RADIO RECEIVERS R-274/FRR, R-274A/FRR, R-274C/FRR, AND R-274D/FRR

TM 11-897

CHANGES No. 2

CHANGES }
No. 1 }

Figure 49.1. (Added) Radio receiver R-874D/F RR, schematic diagram.

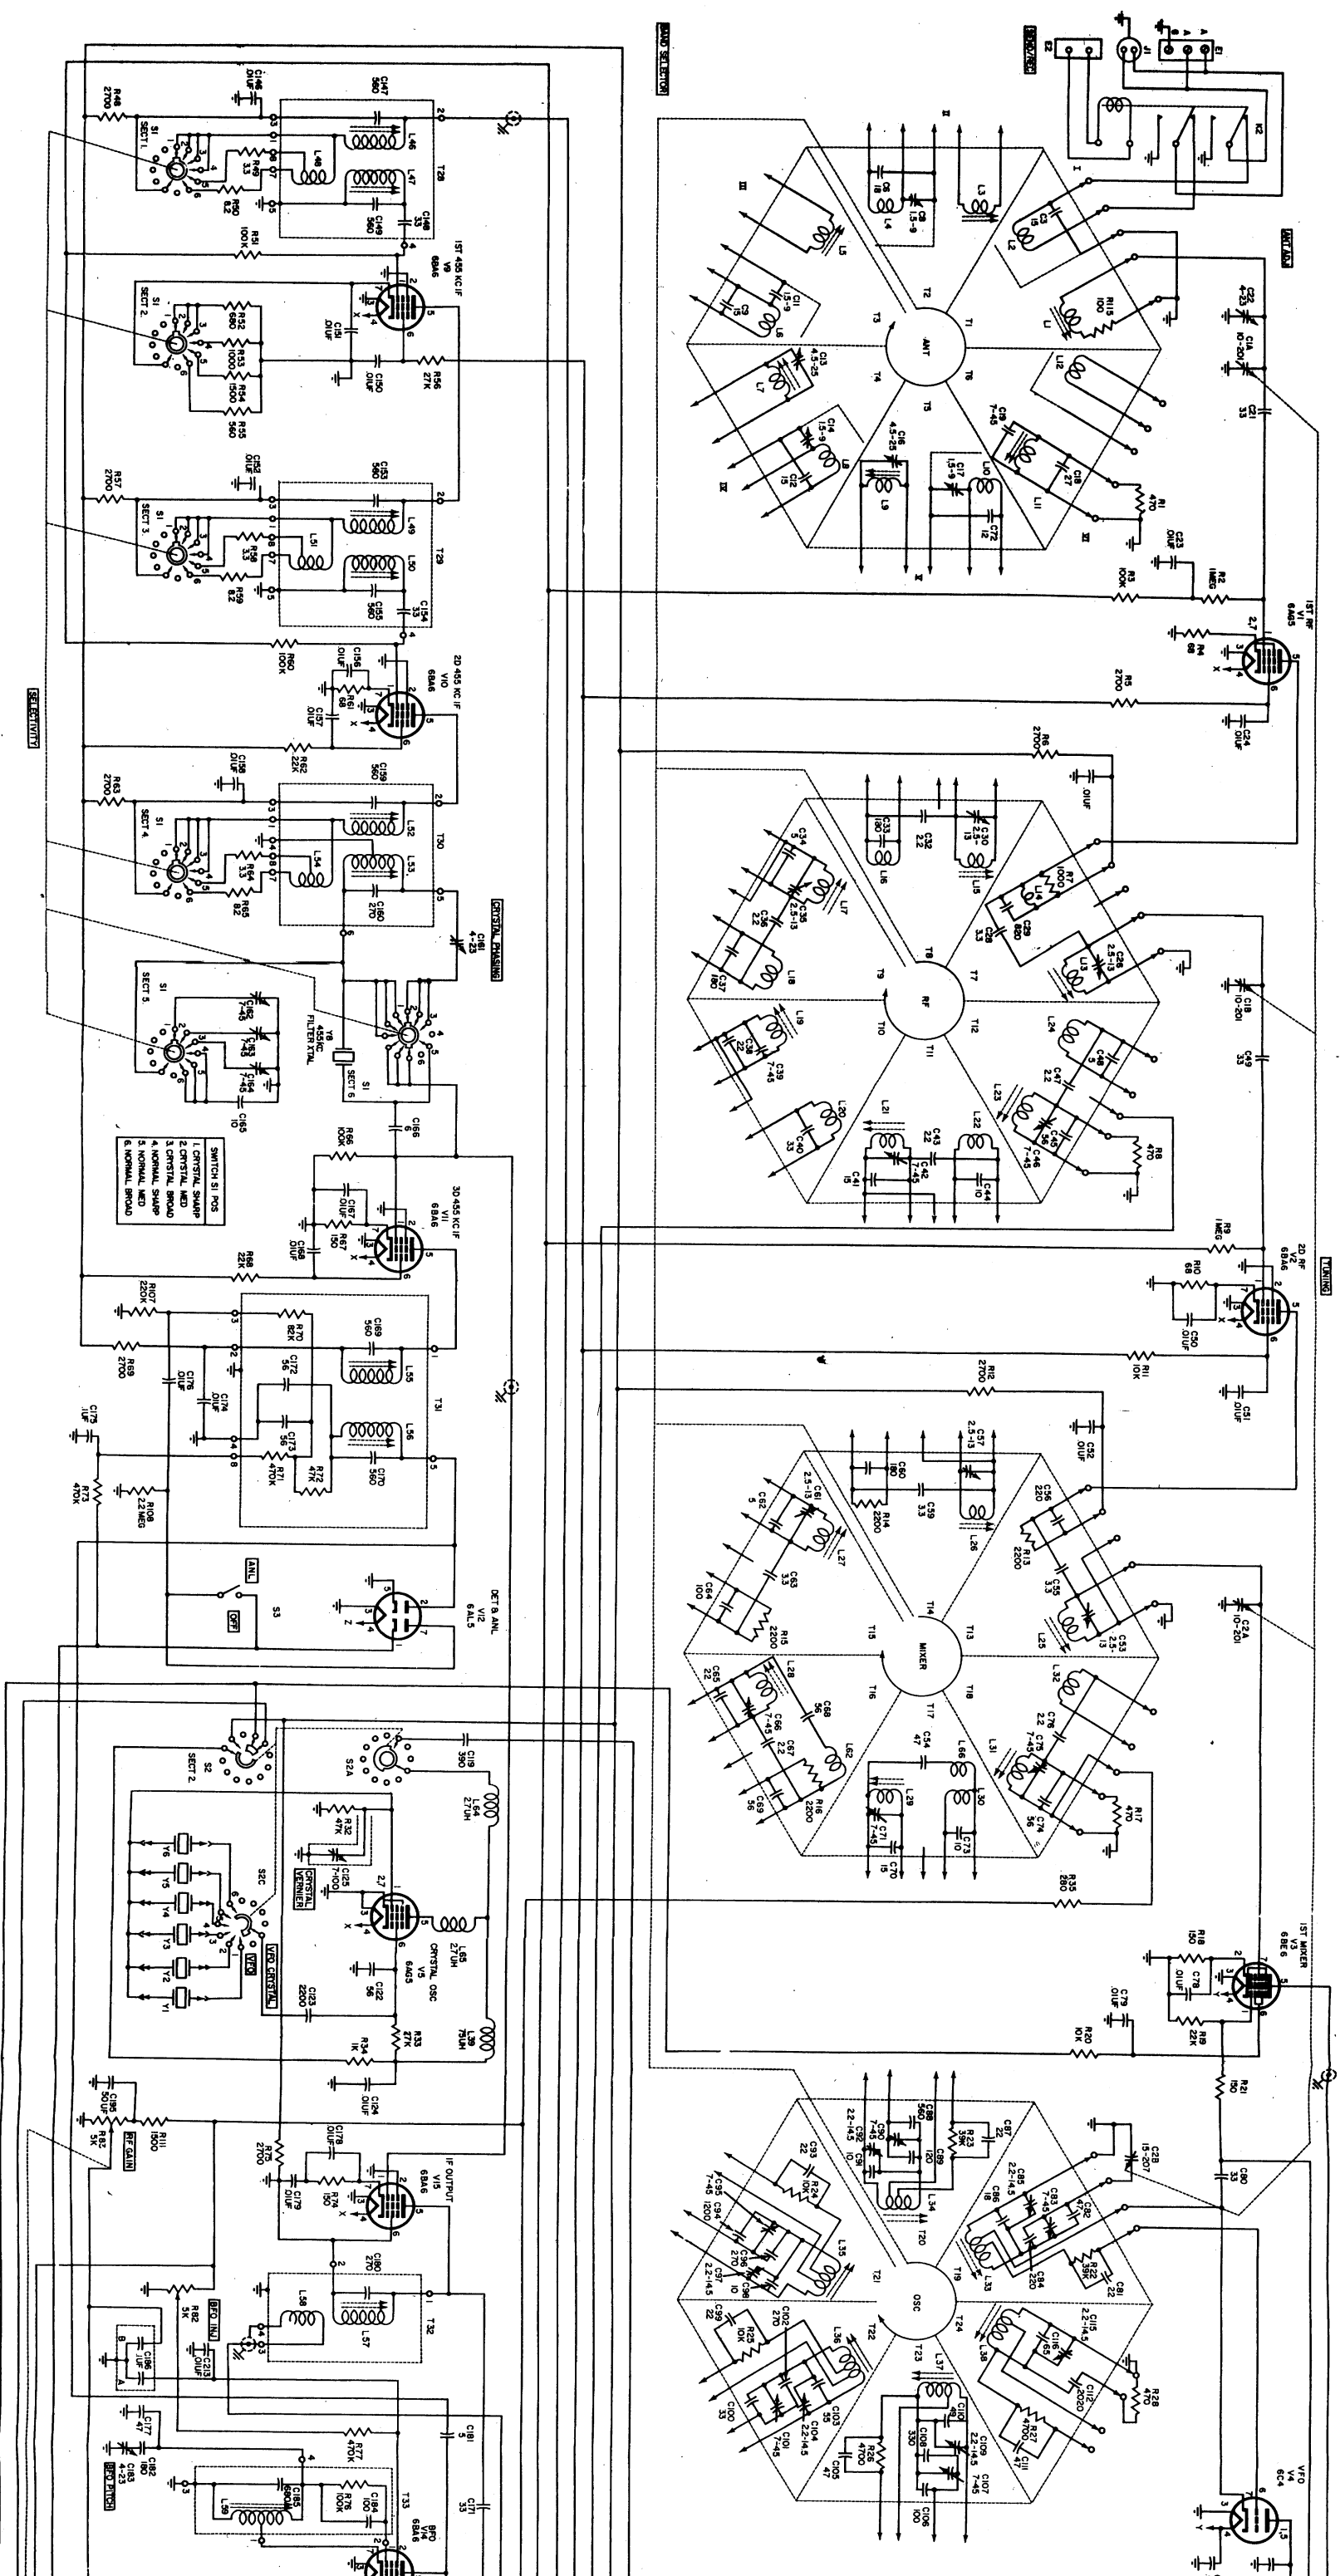
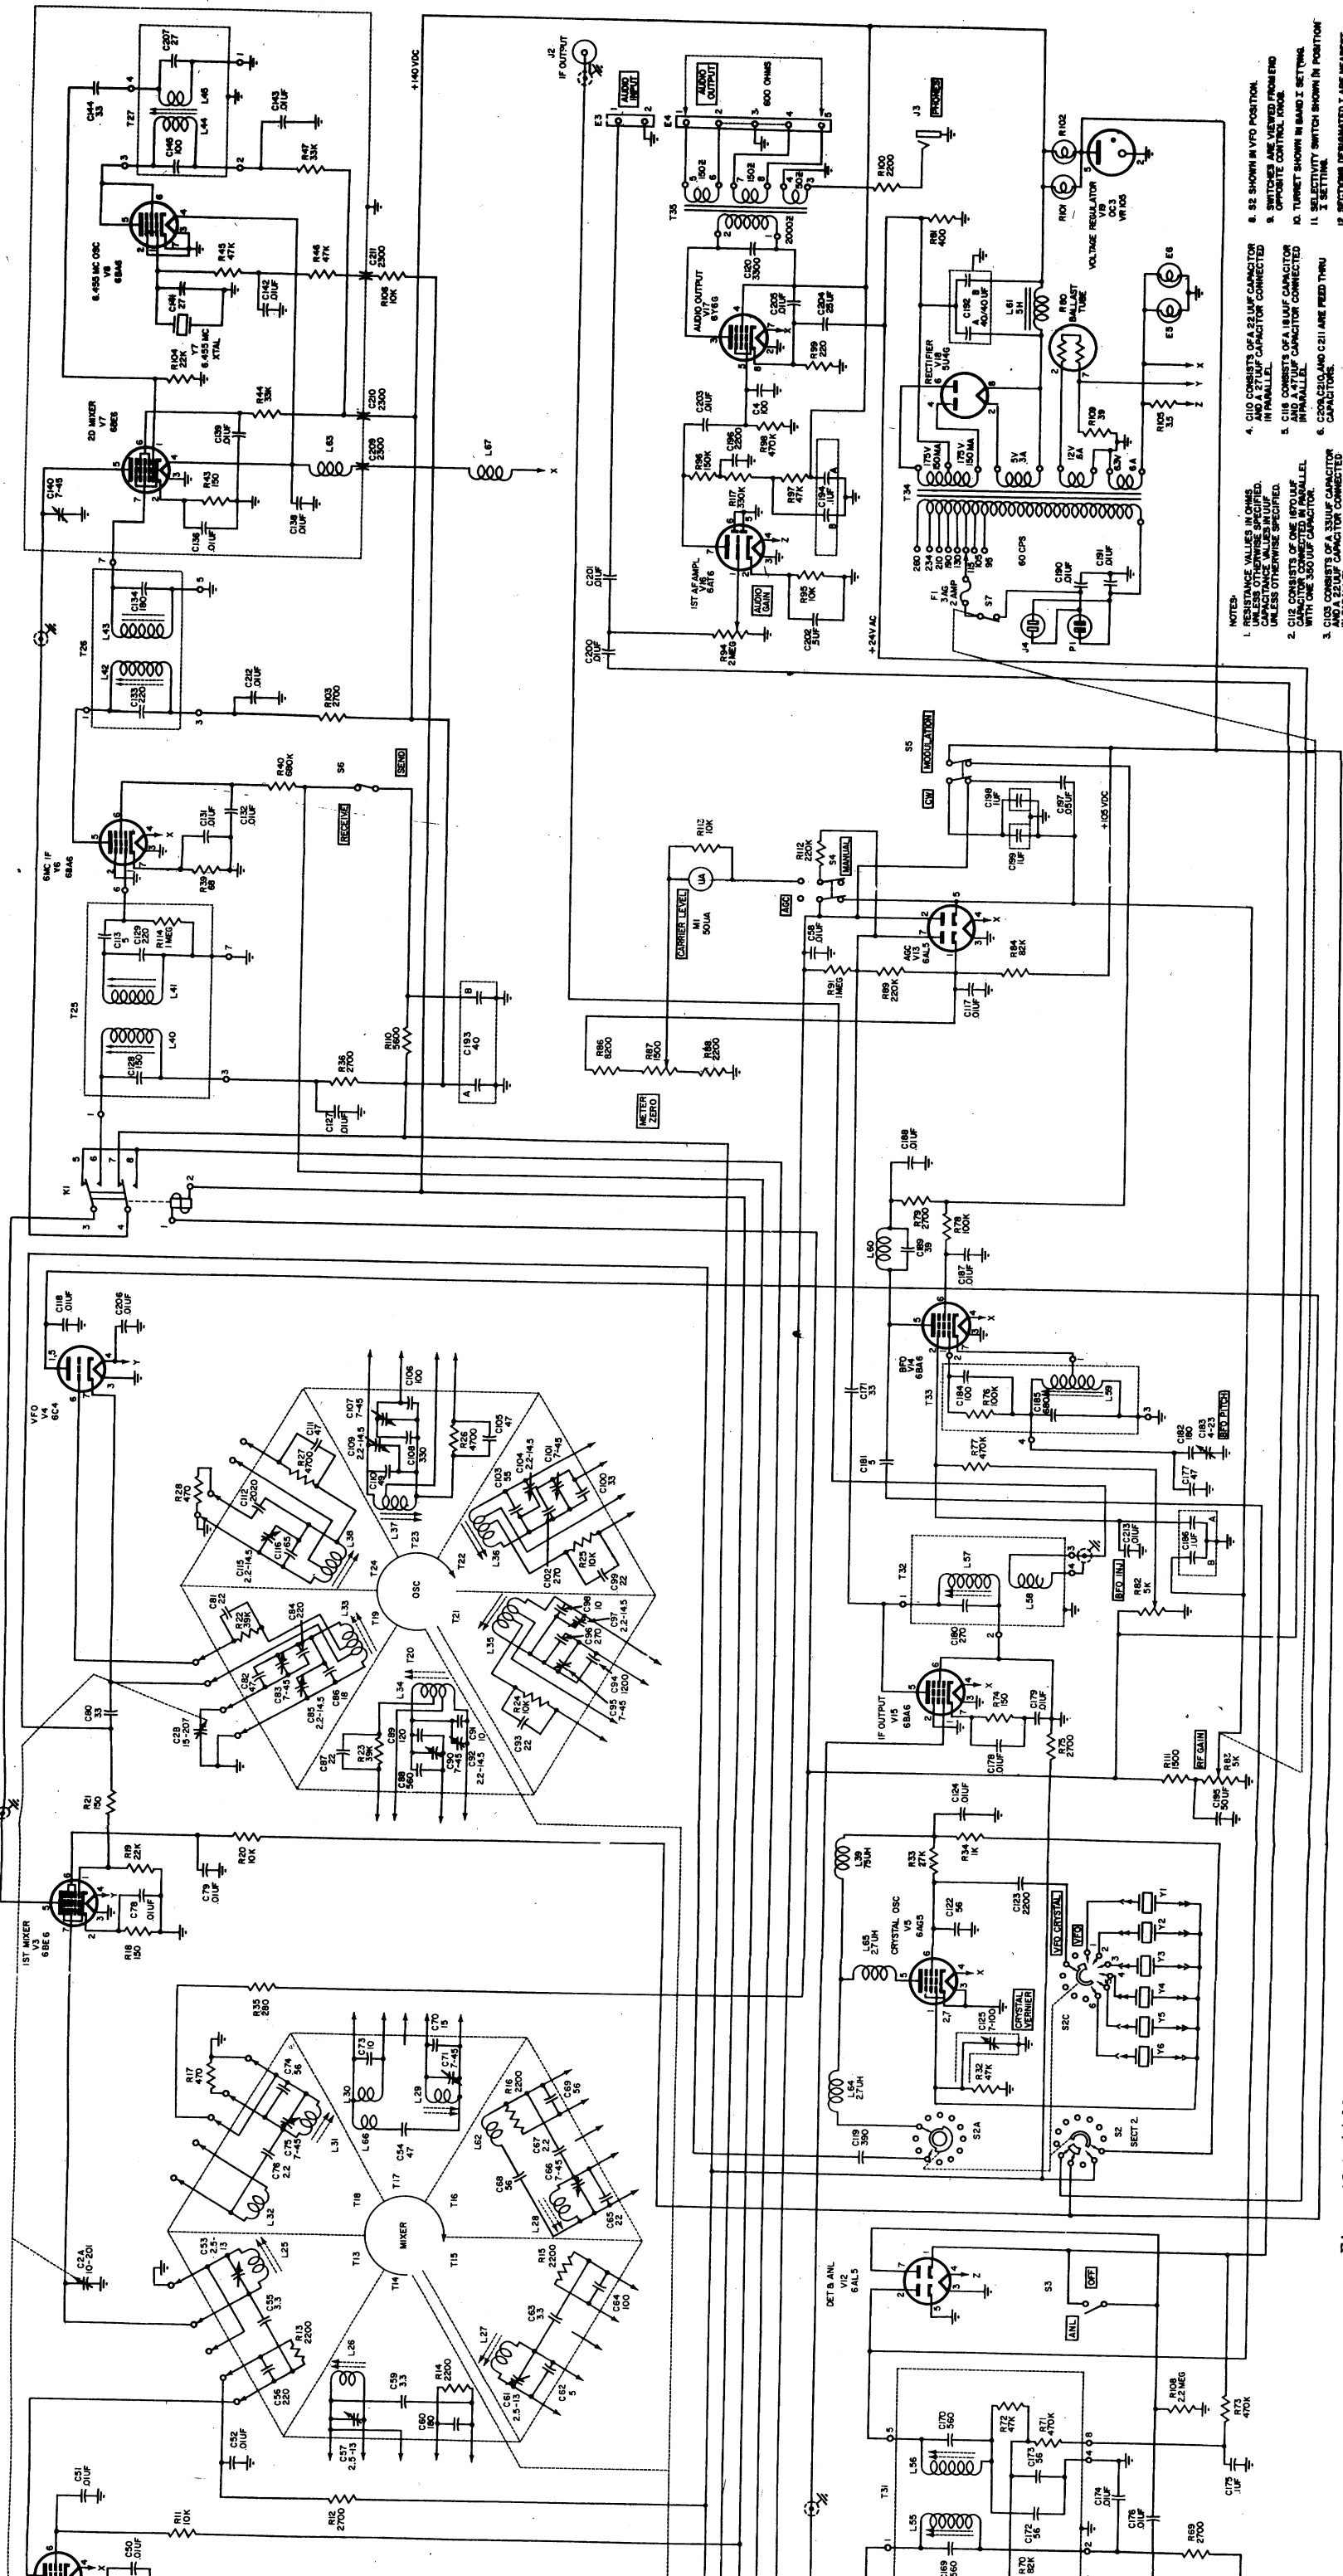
Figure 43.1. The following note is added:

14. IN RADIO RECEIVER R-274D/FRR, SERIAL NUMBERS 674 THROUGH 1266 ON ORDER NO. 3464-PHILA-52, A NEON LAMP E53 IS CONNECTED ACROSS THE ANTENNA DISABLING RELAY CONTACTS.
